**NSLPP MEETING HELD ON 06/12/23****Attachments:**

**ADDRESS/WARD:** 184B, 186 and 190 Kurraba Road, Kurraba Point

**APPLICATION No:** DA 343/22

**PROPOSAL:** Demolition of a dwelling house, two (2) dual occupancies and a swimming pool and construction of two x residential flat buildings and 2 x dual occupancies, with basement parking and access provided by car lifts, associated landscaping and civil works and internal boundary realignment and subdivision.

ELEVATION SOUTH

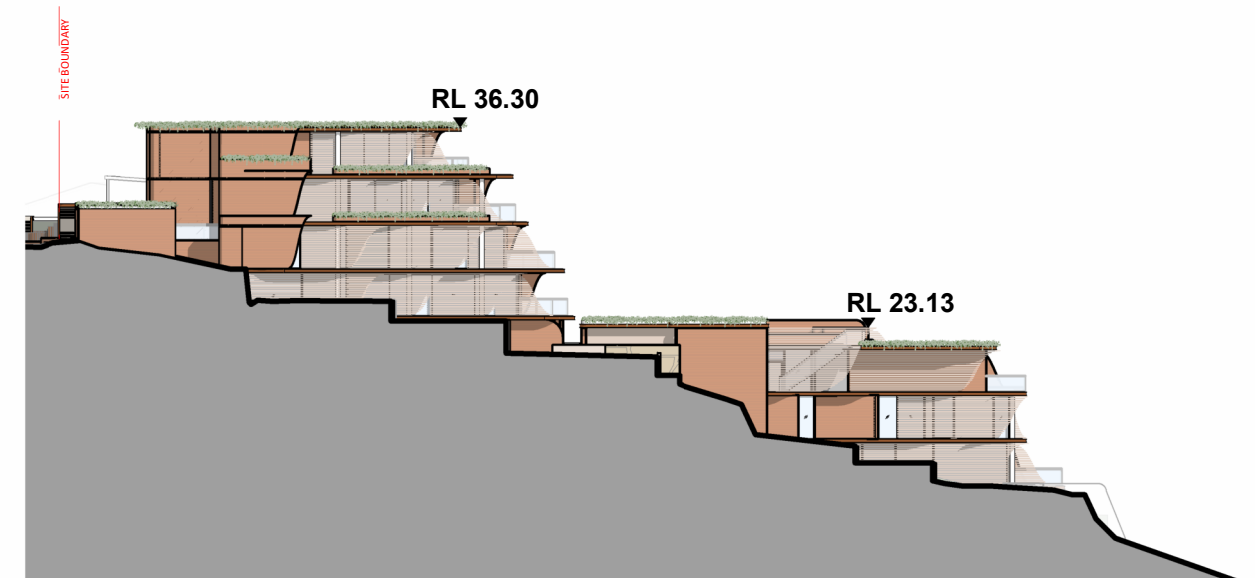
There appears to be an excessive amount of excavation, as much as two levels below ground is indicated on Drawing A203 (South Elevation). Further level details are required to properly assess the impact.
